Appendix A: Schedule of Changes to Drawings

Schedule of changes to drawings - Rev A to Rev C

Anglia Square Rev A - Rev C Supporting Information

January 2023

Block A - East Elevation

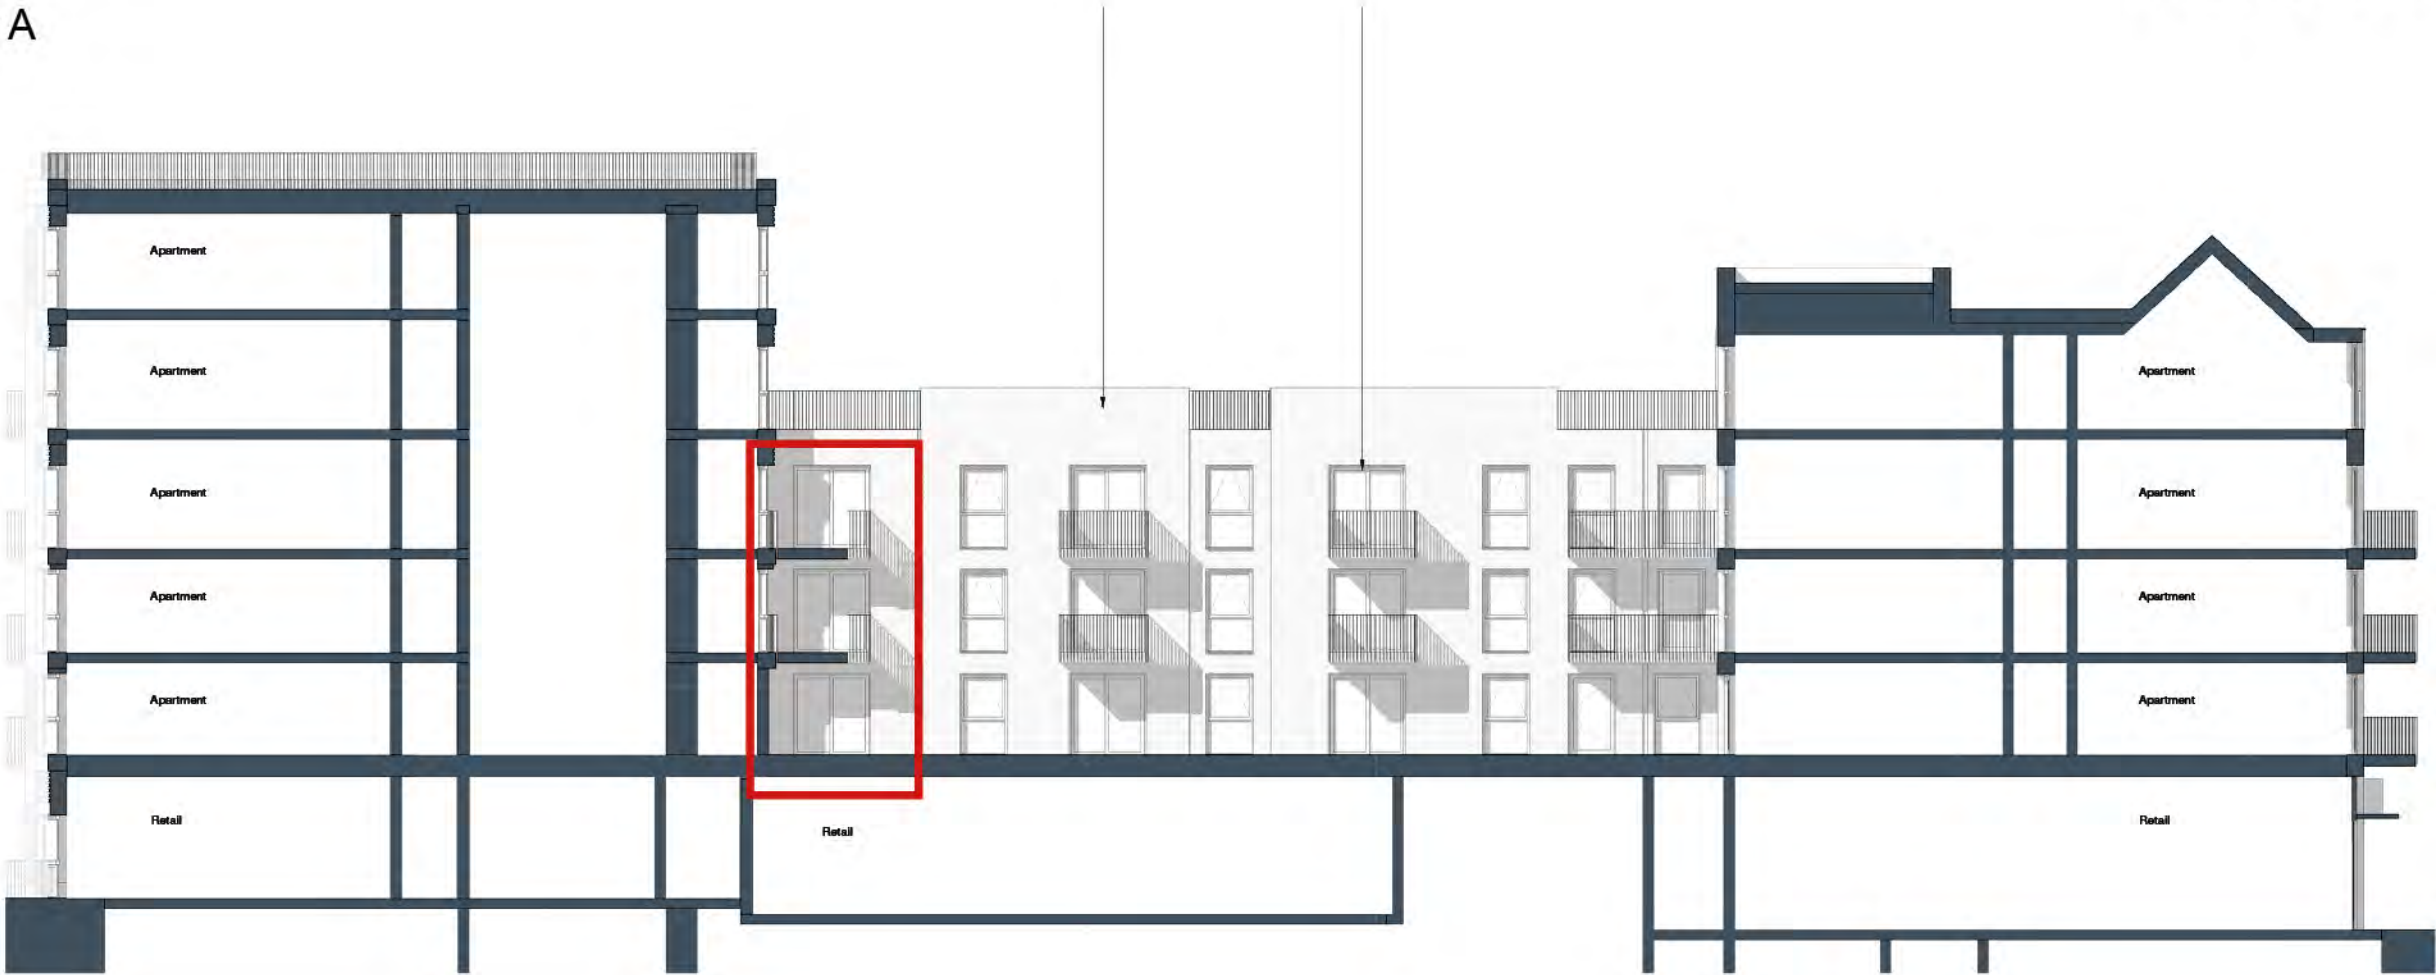
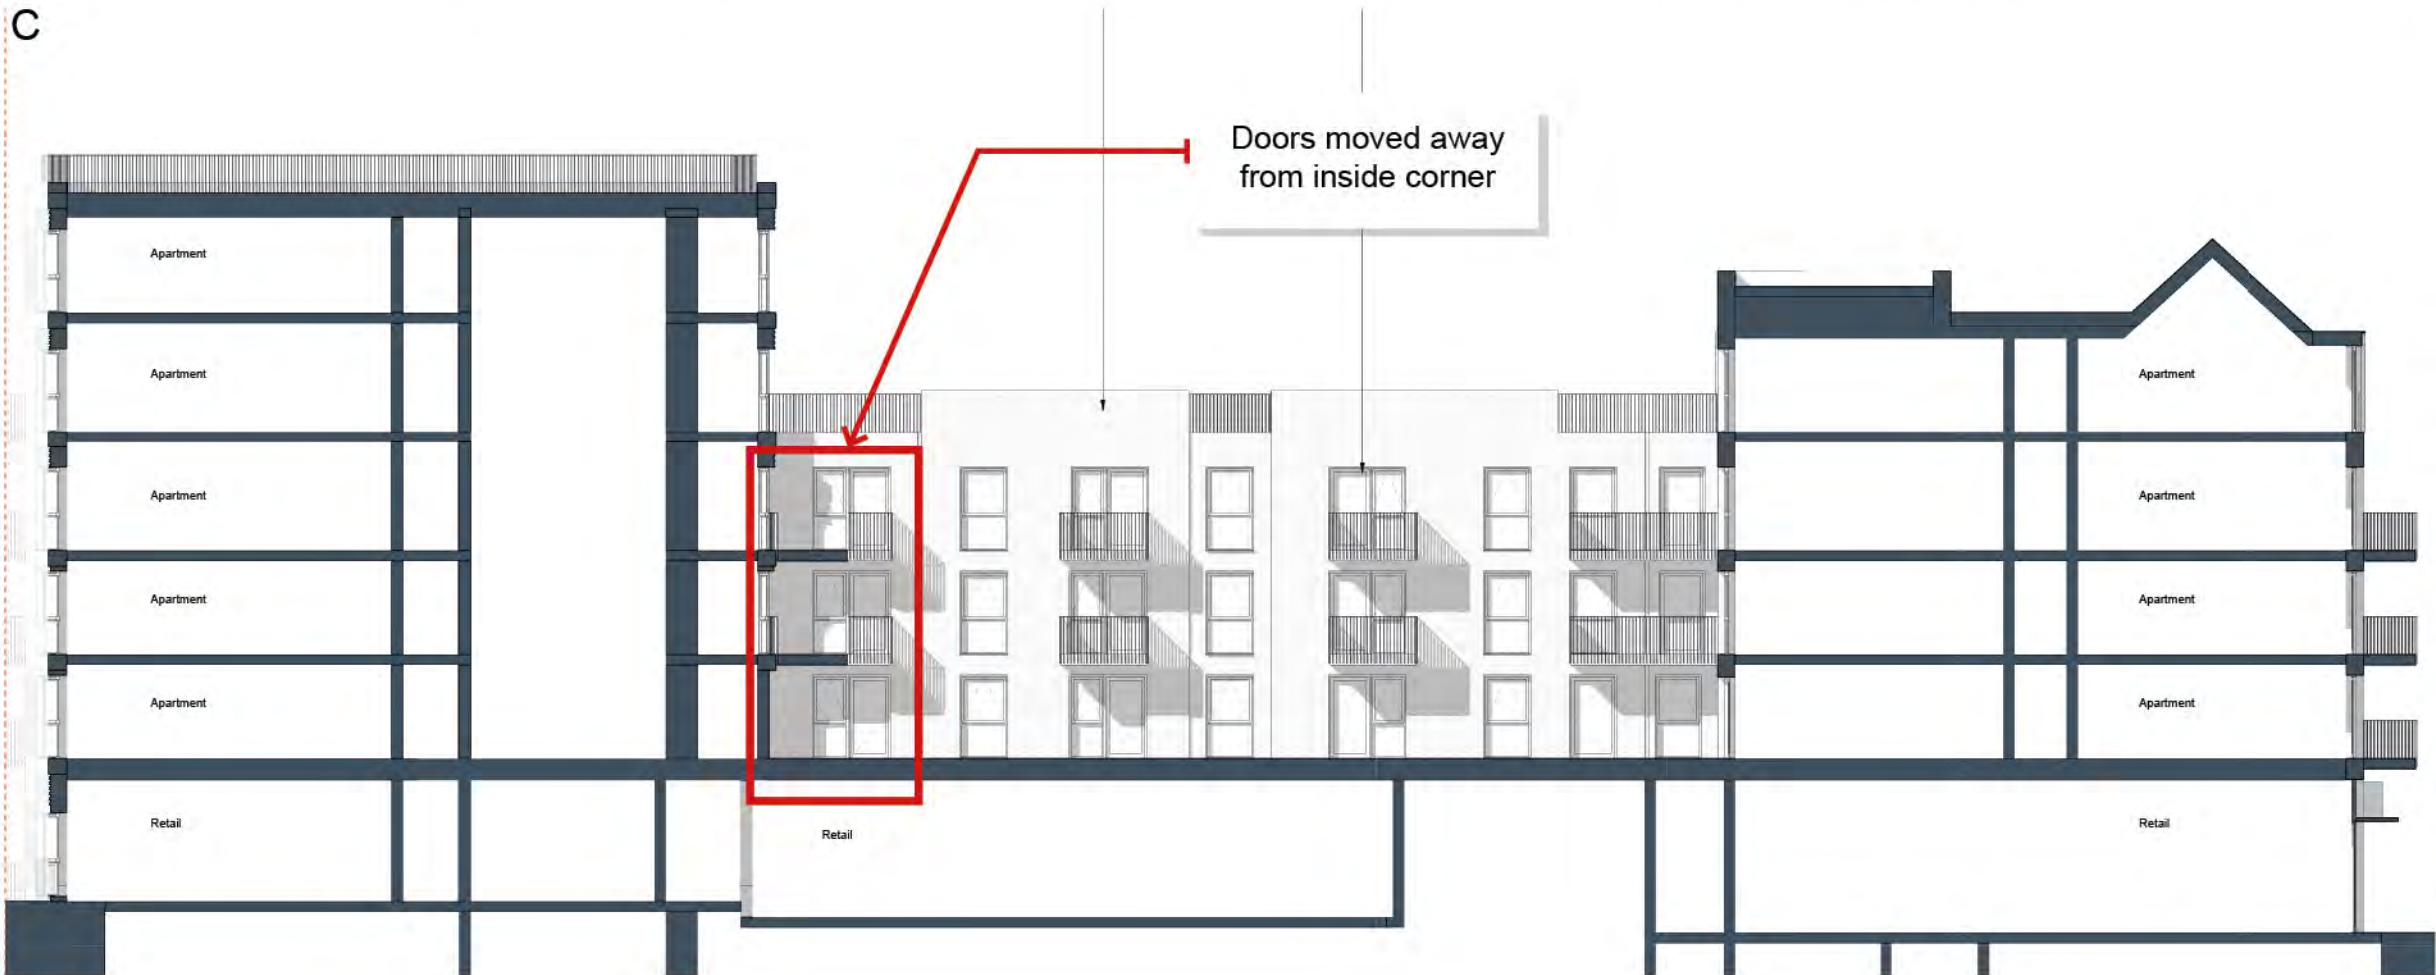
No.	Amendment	Plan / Document Updated
BLOCK A (Detailed Element)		
1	66 of 91 units tested for daylight and sunlight have had internal layouts amended. 18no. of those units have also had external changes, involving windows adjusted / balconies repositioned or moved.	Masterplans: 35301-ZZ-00-DR-A-01-0099 - 35301-ZZ-00-DR-A-01-0199 GA Plans: 35301-ZA-00-DR-A-03-0099 - 35301-ZA-00-DR-A-03-0107 Elevations: 35301-ZA-00-DR-A-05-0300 - 35301-ZA-00-DR-A-05-0307 Internal Daylight, Sunlight & Overshadowing Report
2	66 units re-tested with amendments to internal layout / window / balcony, as above.	Internal Daylight, Sunlight & Overshadowing Report
3	Ground floor internal cycle store and refuse store swapped positions to allow refuse strategy to comply with NCC standards	Masterplans: 35301-ZZ-00-DR-A-01-0100 GA Plans: 35301-ZA-00-DR-A-03-0100 Refuse Strategy
4	Residential lobbies on north and east of Block A ground floor to have threshold level raised / entry hump added to assist with flood strategy	Flood Risk Assessment

Block B Houses - North and South Elevations

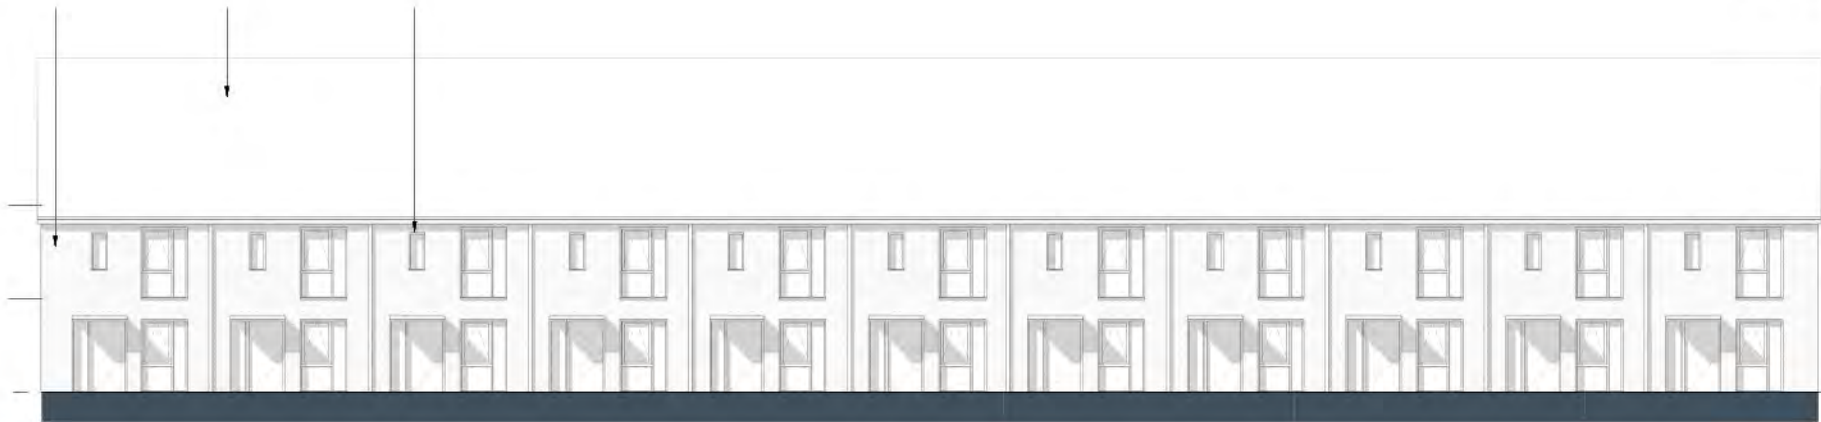
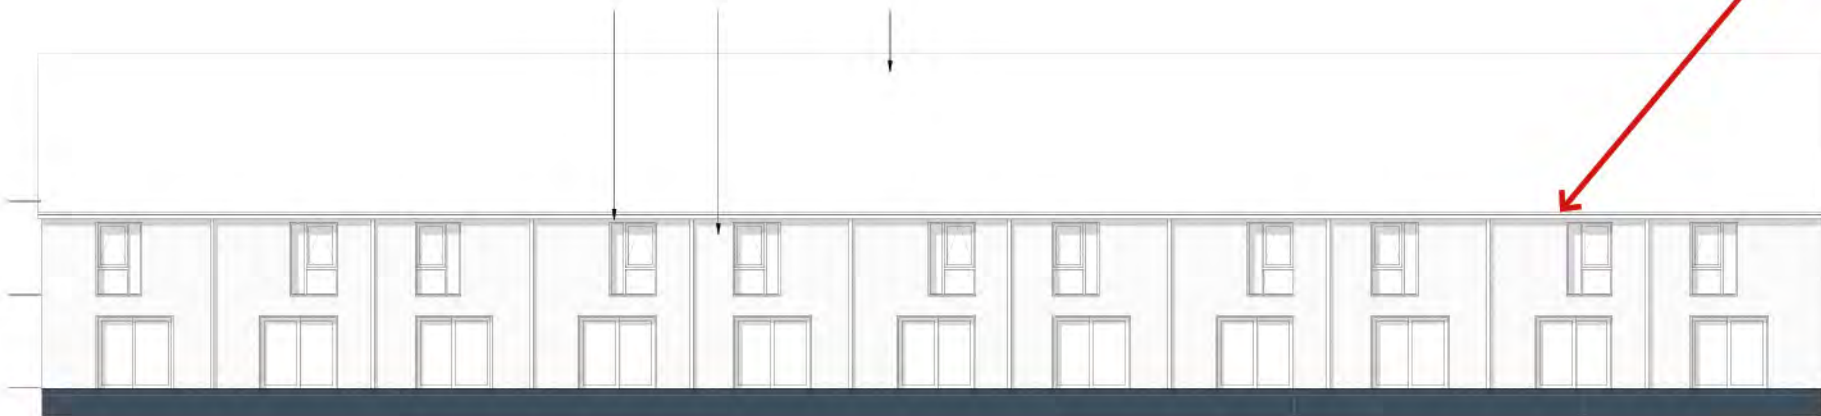
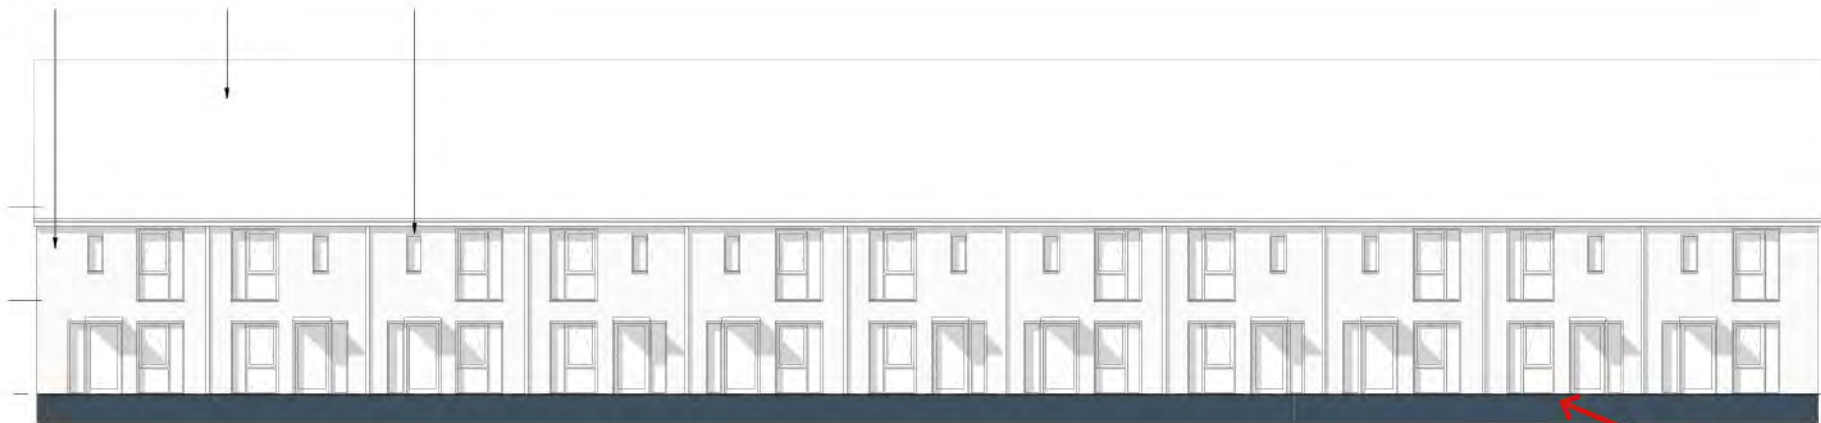
Internal layout, and window and door positions amended so pairs of houses mirror each other, allowing for private bin and bike stores to be added.
Roof material changed from dark grey roof tile to blue pantile.

Block B - Landscape

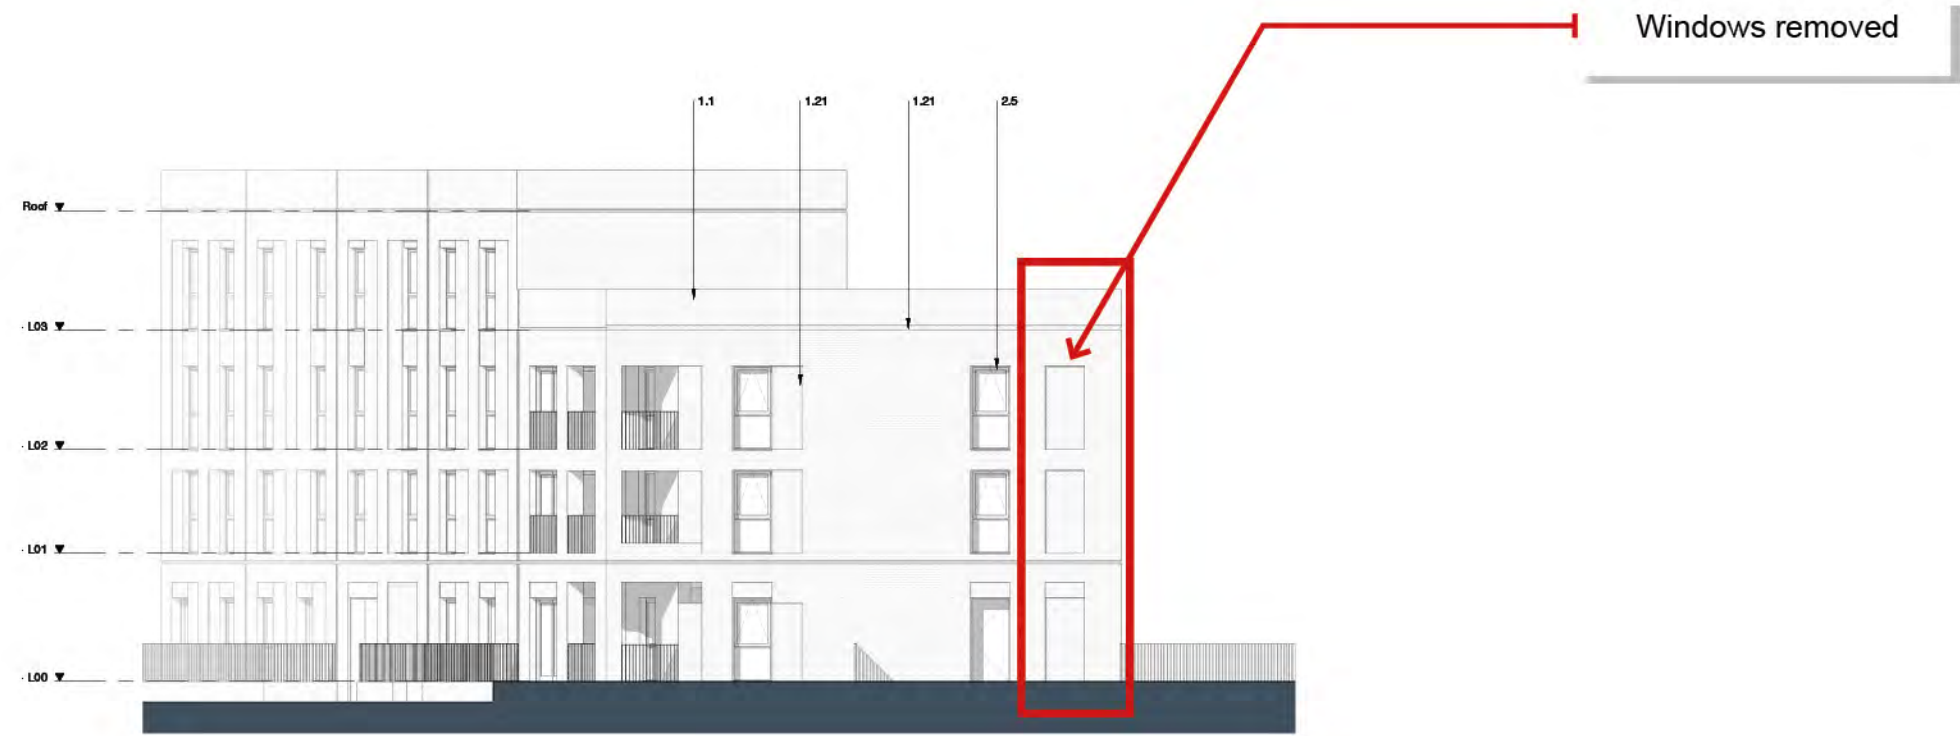
Elevation reverted back to original design
